Access Compliance Report

Public Rights-of-Way

Intersection ID: 42472	Main Street: CASTLE_WATCH_AV	Cross Street: WINDSOR_CASTLE_LN	Location: NW
ADA ID: C0E30C145FB0	Ramp Type: PerpDiag	Initial Pass/Fail: Fail	Overall Compliance: No
Severity Score: 25			
Codes/Mitigation Info/Possible Solution		Field Measurements/Component Compliance

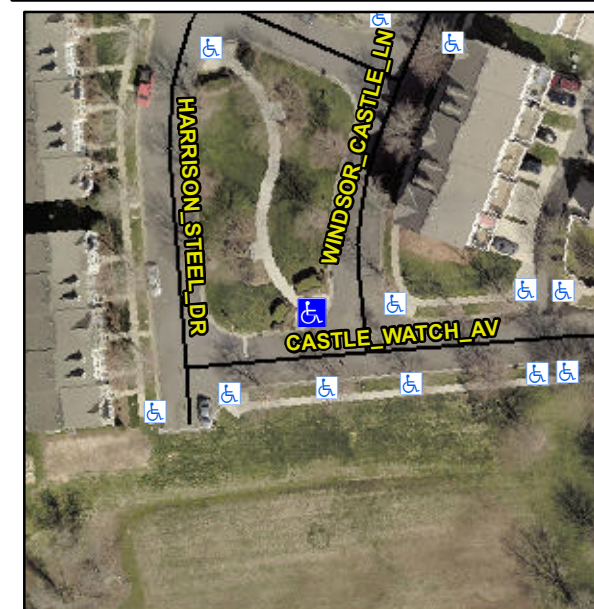
Compliance	Description	Data	Compliance	Description	Data
N/A	Ramp Length (in)	279.0	Yes	Ramp Slope (%)	12.4
Yes	Ramp Width (in)	60.0	Yes	Ramp XSlope (%)	2.0
N/A	Flare Type LT	N/A	N/A	Flare Type RT	N/A
N/A	Flare Slope LT (%)	N/A	N/A	Flare Slope RT (%)	N/A
N/A	Flare Traversable LT?	N/A	N/A	Flare Traversable RT?	N/A
N/A	Landing Length (in)	N/A	N/A	DWS Provided?	N/A
N/A	Landing Width (in)	N/A	N/A	DWS Contrast?	N/A
N/A	Landing Slope (%)	N/A	N/A	DWS Length (in)	N/A
N/A	Landing X Slope (%)	N/A	N/A	DWS Full Width?	N/A
N/A	Landing Curb? (Y/N)	N/A	N/A	DWS Offset (in)	N/A
N/A	Shared Landing?	N/A			
N/A	Gutter Ponding?	N/A	N/A	Gutter Slope (%)	N/A
N/A	Gutter Lip Ht (in)	N/A	N/A	Gutter X Slope (%)	N/A
N/A	Painted X Walk1?	No	N/A	Painted X Walk2?	No
	X Walk 1 Direction	To S		X Walk 2 Direction	To E
N/A	X Walk 1 Width (in)	N/A	N/A	X Walk 2 Width (in)	N/A
	X Walk 1 Slope (%)	0.5		X Walk 2 Slope (%)	4.3
	X Walk 1 X Slope (%)	4.0		X Walk 2 X Slope (%)	0.5

Remove & Replace Curb Ramp With Two New Directional Ramps or Equivalent.
